PD Modification Application: PRS 23-0375

Hillsborough County Florida

Development Services Department

The applicant requests a **Minor Modification to the PD 22-0685 conditions of approval, to remove Condition 4 regarding the construction of a sidewalk along Crestwood Drive.** Condition 4 was added at the BoCC August 15, 2022, public hearing pursuant to the applicant’s request and subsequent discussion during the BoCC with the applicant. No additional revisions are requested by the applicant.

2.5 Proposed Site Plan (partial provided below for size and orientation purposes. See Section 8.2 for full site plan)

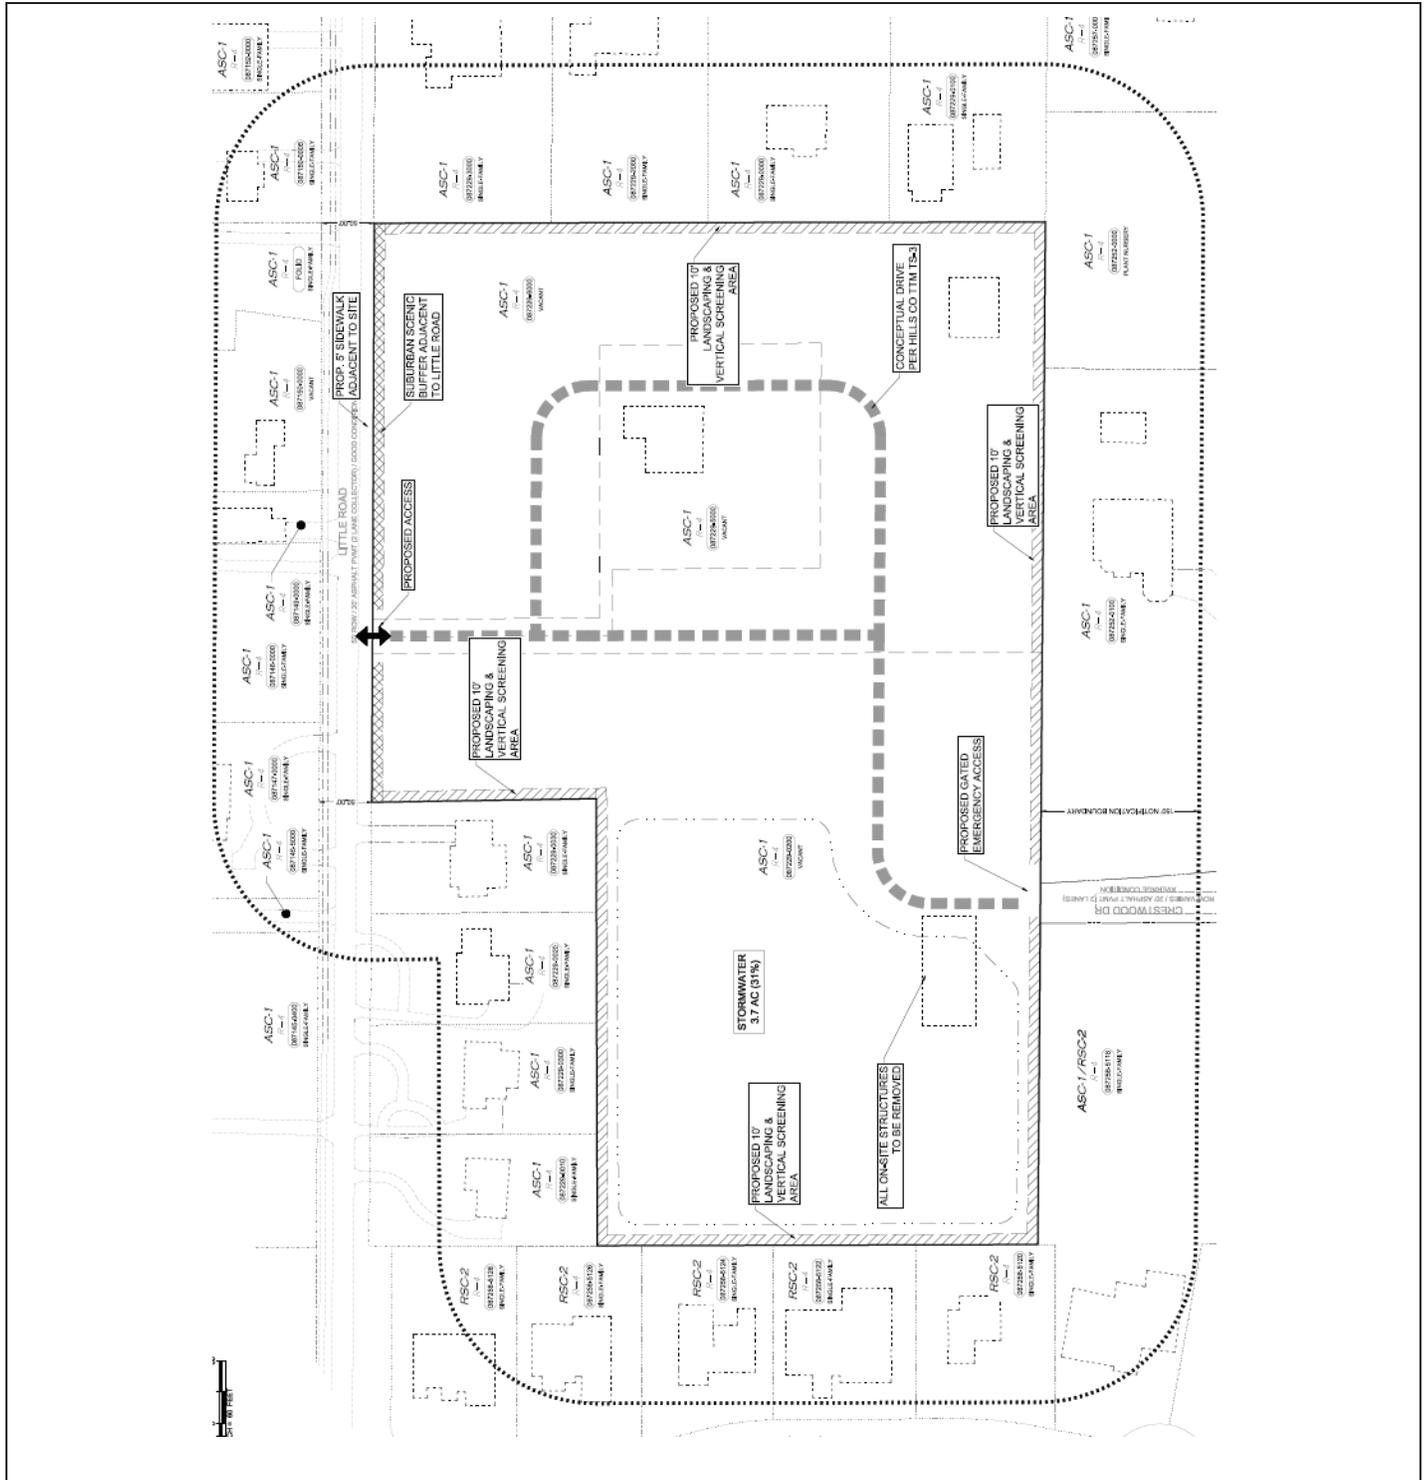
The applicant's proposed PD site plan does not depict the required pedestrian access on Crestwood Dr. as required by the Condition of Approval #7, which states (italics and underline add for emphasis) "An emergency vehicle and *pedestrian access connection shall be constructed to Crestwood Drive*, as shown on the PD site plan.". County Development Procedures Manual (DRPM), Sec. 6.2.1. C. 7. – Transportation Information subsection a. states that proposed points of ingress and egress for pedestrian facilities must be depicted on the site plan. The proposed PD site plan only shows gated emergency access at the Crestwood Dr. connection.

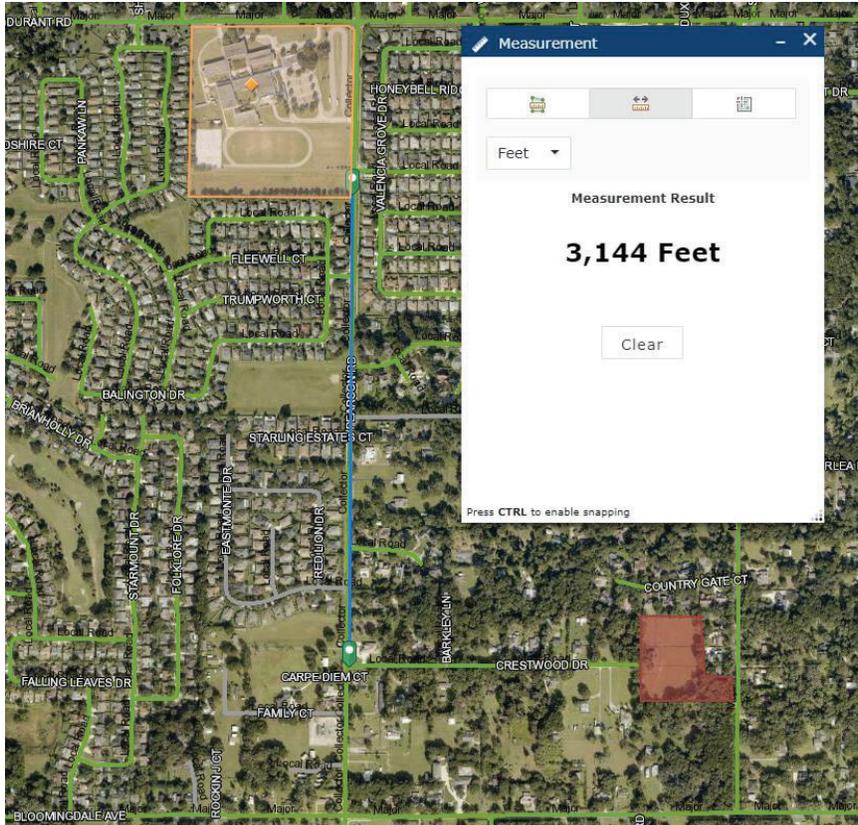
Mulrennan Middle School is the closest school facility to the subject planned development. The location of the subject planned development (PRS 23-0375) and Mulrennan Middle School are shown in the aerial below.

The yellow line is the most direct pedestrian route (+/-5,085ft or 0.96 mile) to Mulrennan Middle School from the subject site and with the sidewalk currently required to be constructed would have a continuous sidewalk network from the project's pedestrian access to the school.

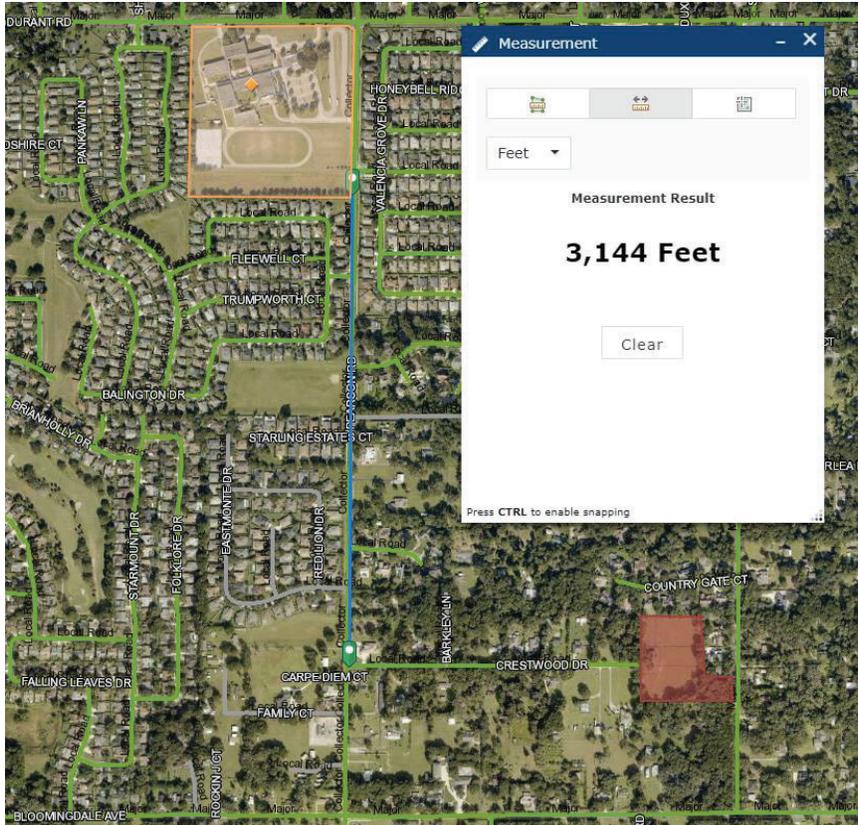
Mulrennan Middle School is the closest school facility to the subject planned development. The location of the subject planned development (PRS 23-0375) and Mulrennan Middle School are shown in the aerial below.

The yellow line is the most direct pedestrian route (+/-5,085ft or 0.96 mile) to Mulrennan Middle School from the subject site and with the sidewalk currently required to be constructed would have a continuous sidewalk network from the project's pedestrian access to the school.
